Access Compliance Report

Public Rights-of-Way

(Curb Ramps)

Intersection ID: 9762	Main Street: CAMBRIDGE COMMONS DR	Cross Street: WOODHILL MANOR CT	Location:	E
ADA ID: 54B26E234D77	Ramp Type: Directional1	Initial Pass/Fail: Fail	Overall Compliance: No	Severity Score: 10
Codes/Mitigation Info/Possible Solution		Field Measurements/Component Compliance

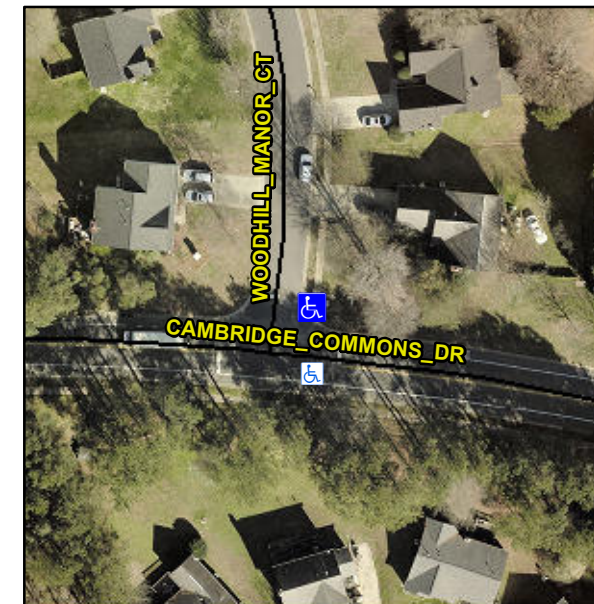
CURB GAP 1.0"

R304.5.1, R304.5.3

Remove & Replace Entire Ramp.
